ADDRESS: 252 QUINCE ST

Proposal: Legalize as-built roof and dormers

Review Requested: Final Approval

OVERVIEW: This application proposes to legalize the as-built roof and dormers at 252 Quince Street, which deviate from the plans approved by the Historical Commission in December 2023. Deviations from the approved plans include the removal of original roof and framing, removal of front and rear cornices, construction of a roof above the location of the original roof, and installation of new dormers that differ in proportions from the approved dormers. This application for legalization was prompted by a staff site visit and subsequent issuance of a violation by the Department of Licenses and Inspections for construction that exceeded the approved plans.

A-201	EXTERIOR ELEVATIONS
DANIELLE HARVEY	
252 QUINCE ST.	
PHILADELPHIA PA 19107	
	10/7/2024

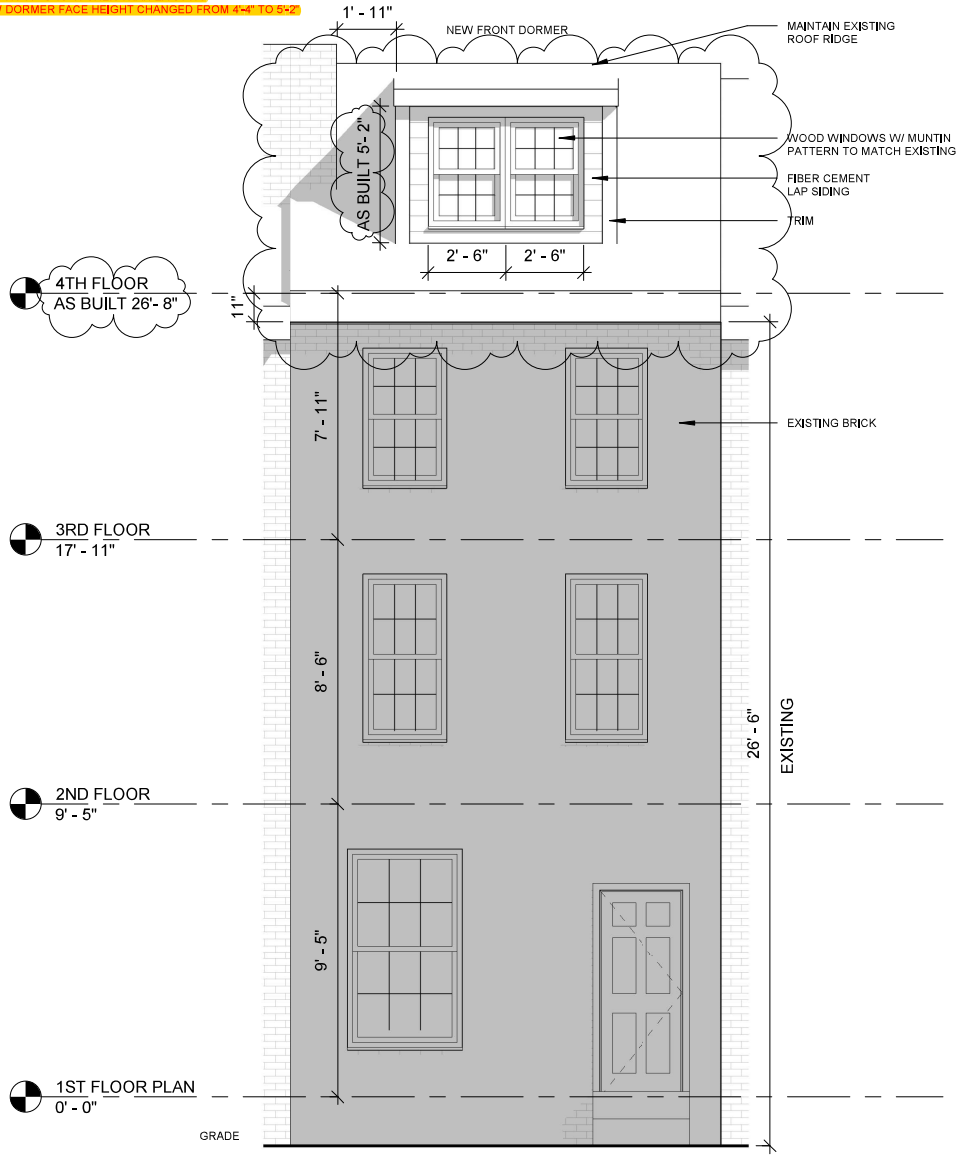
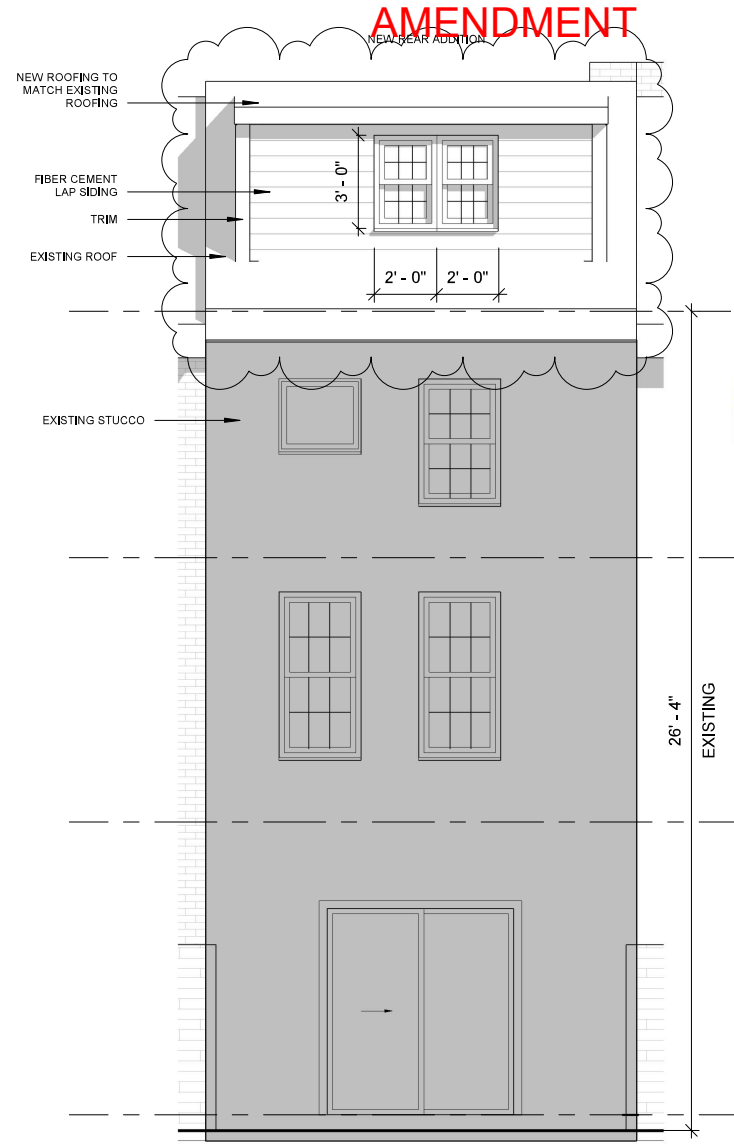
- The gable roof, which was constructed above the location of the historic roof, and dormers, which were constructed taller than approved, are incompatible with the historic property and environment and fail to satisfy Standard 9.

- Front and rear dormers were constructed 10 inches taller than approved plans and the dormer cornices are oversized. As currently constructed, the dormers are highly visible from the public right-of-way and fail to satisfy the roof guideline.

AS BUILT CHANGES INCLUDE:
 -EXISTING ROOF AND GORNICES REPLACED WITH NEW
 -NEW ROOF IS 10" HIGHER THAN EXISTING
 -NEW DORMER FACE HEIGHT CHANGED FROM 4'-4" TO 5'-2"

STAFF RECOMMENDATION: Denial, pursuant to Standard 9, 10, and Roofs Guideline.

A-201 EXTERIOR ELEVATIONS
DANIELLE HARVEY
252 QUINCE ST.
PHILADELPHIA PA 19107
12/20/2023

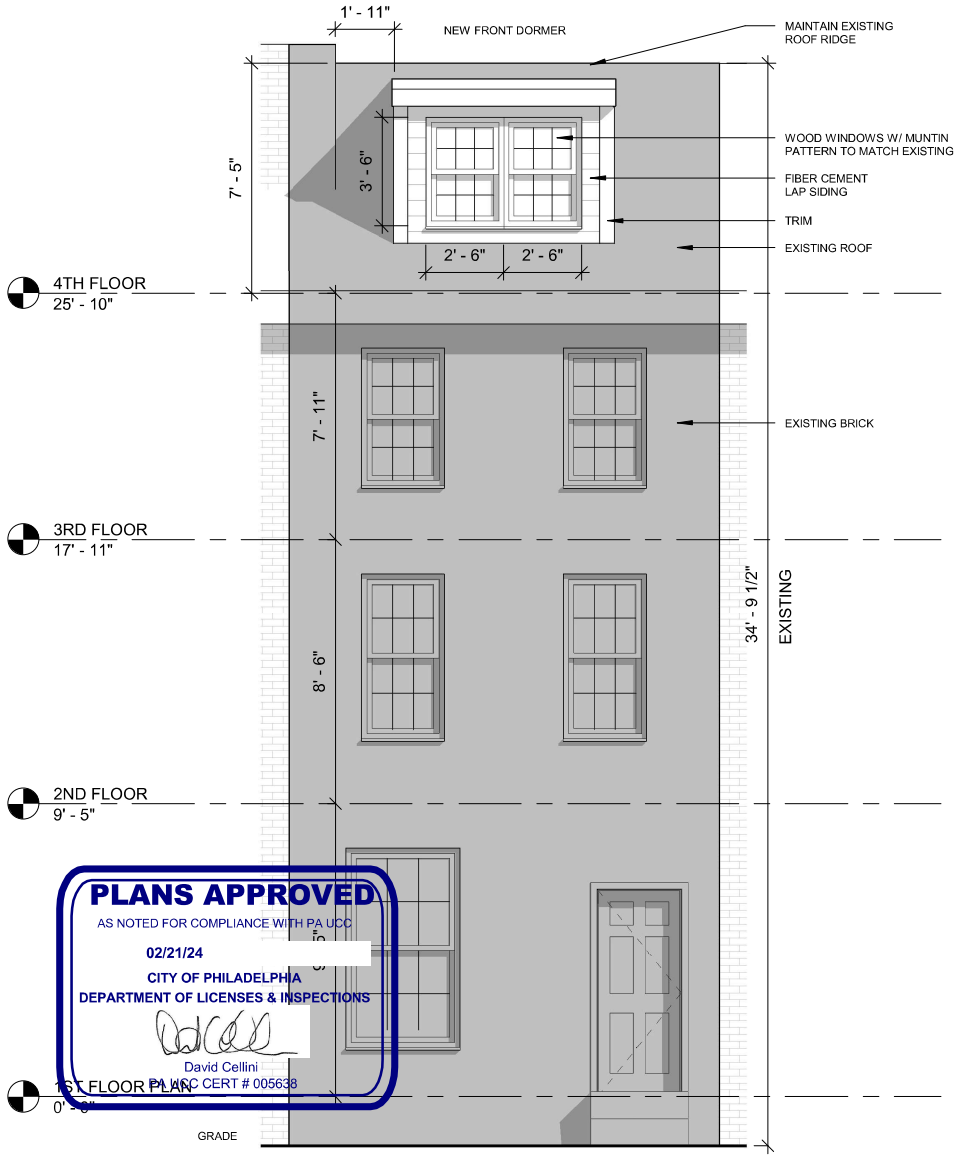
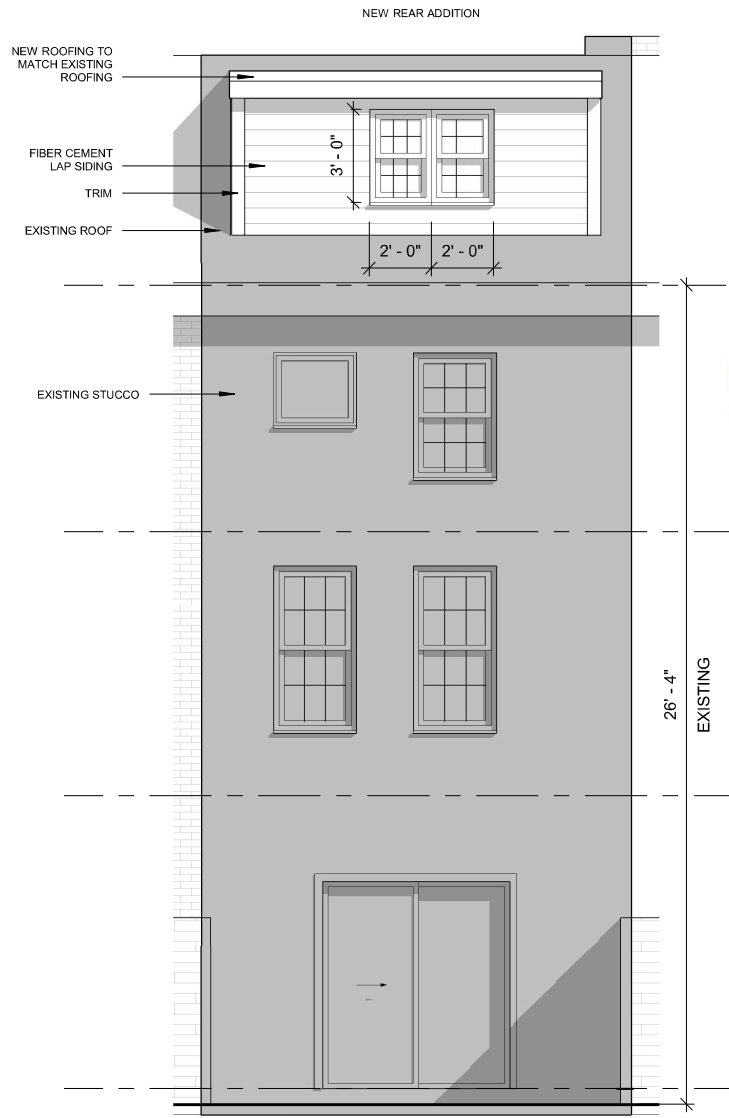
- If the front dormer is set back from the front façade and the rear addition is reconceived as a dormer, the dormers could be inconspicuous from the public right-of-way.

STAFF RECOMMENDATION: Approval, provided the front dormer is set back from the plane of the front façade and the rear addition is redesigned as a dormer that is set in from all sides to allow the original roof rafters and slope to remain visible, with the staff to review details, pursuant to Standards 9, 10 and the Roofs Guideline.
